Technical Bulletin

TSB No. TS 07 07187R

SUBJECT: FRONT BRAKE SQUEAKING
MODEL(S): GRAND VITARA (SQ625W), GRAND VITARA XL-7 (JA627)
YEAR: 1999~2005 GRAND VITARA ALL
 2001~2004 GRAND VITARA XL-7 SEE AFFECTED VINS

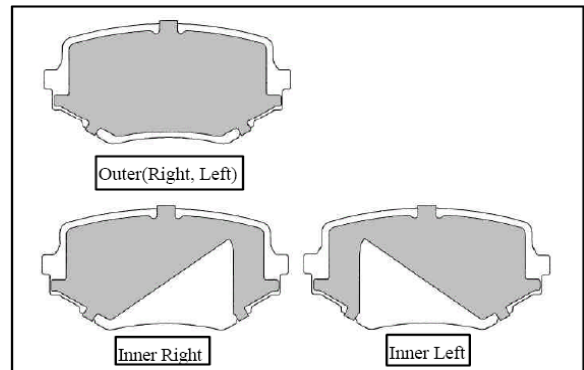
REVISION: The MY range for the XL-7 is 2001~2004
CONDITION: When braking, the front brakes emit a squeaking noise.
CAUSE: The front brake assembly may be amplifying normal operating noise.
CORRECTION: New improved brake pad shims are now available. Follow the service manual instructions for installation procedures. All XL-7s built after the listed VINS above already have the updated shims.

NOTE:
 Remove all of the old shims. Install the new set as shown. Apply included grease between the pad back and the new shim. It is not necessary to replace the disk brake pads during the completion of this repair. Brake pads are a consumable item and will not be covered by warranty.
